The CAISO received comments on the topics discussed at the November 17 stakeholder call from the following:

The following are the CAISO's responses to the comments

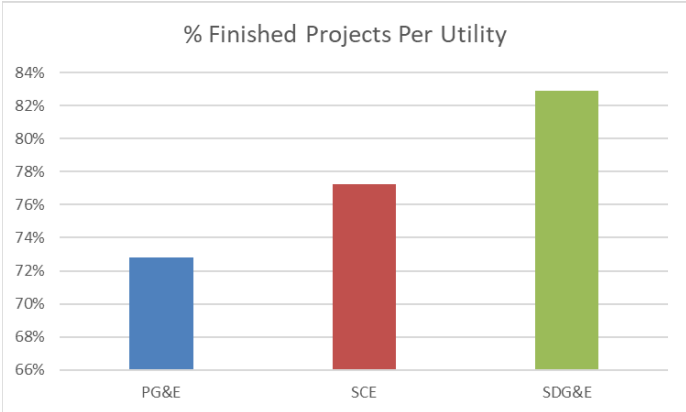
6i	City of San Jose	No comment	
6j	Clearway Energy Group	No comment	
6k	Coalition for the Optimization of Renewable Development	No comment	
6l	Defenders of Wildlife	No comment	
6m	EDF-Renewables	No comment	
6n	Fervo Energy	No comment	
6o	Wellhead Electric Company, Inc.	<p>Wellhead Electric welcomes CAISO's identifying six transmission upgrade options to meet the policy target in the SDG&E area. However, the incremental deliverability associated with each option was not provided, leaving it hard to judge which options provide the biggest bang for the buck. We would like to see that CAISO release data on how much incremental deliverability each upgrade option provides, as well as how the incremental deliverability impact generators in the interconnection queue.</p> <p>We also noticed that the PG&E area presentation provides the amount of BESS needed to mitigate off-peak issues. BESS is an</p>	The comments have been noted.

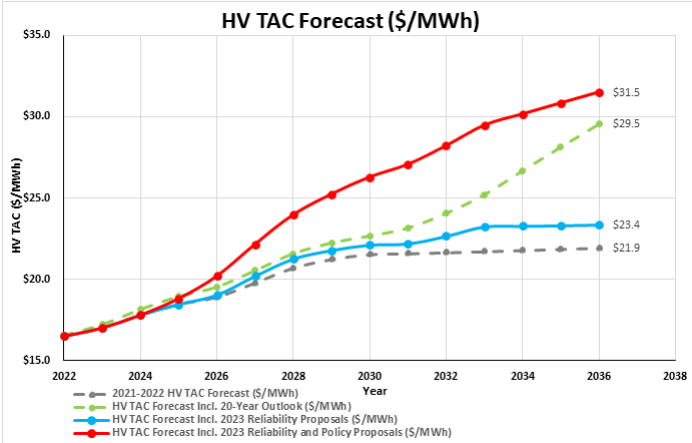
11w	Pacific Gas & Electric	PG&E appreciates the CAISO's efforts in identifying transmission alternatives for thermal resources supported by	Thank you for your comments and inputs. As mentioned at the stakeholder meeting, the ISO performed the special study to provide

No	Submitting Organization	Comment Submitted	CAISO Response
		<p>Aliso Canyon. As demonstrated by the CAISO's preliminary analysis, Aliso Canyon provides significant local area support. However, based on the available information, it appears the CAISO's analysis for summer peak assumes FTI Consulting's winter peak estimates of reduction in thermal capacity due to Aliso Canyon retirement. In addition, the CAISO's analysis did not address cost effective resource alternatives to transmission.</p> <p>Given the significance of Aliso Canyon for local area reliability and significant cost involved in replacing the local resources, PG&E recommends the CAISO to collaborate with the CPUC to:</p> <ol style="list-style-type: none"> 1. Develop an estimate of reduction in thermal capacity during non-winter peak months. 2. Revise the current TPP analysis for summer peak and winter peak months. 3. Consider cost effective resource alternatives in the local area to address the local capacity needs. <p>PG&E is providing a detailed process recommendation to plan for Aliso Canyon retirement in the CPUC's Aliso Canyon Order Instituting Investigation.</p>	<p>preliminary study results for informational purpose at this time. The study assumptions are based on the available publicly data from the CPUC that the ISO can obtain at this time. In the event of future availability of further detailed data from the CPUC for the conditions in which PG&E suggested here, the ISO may consider updating the special study with new assumptions.</p>
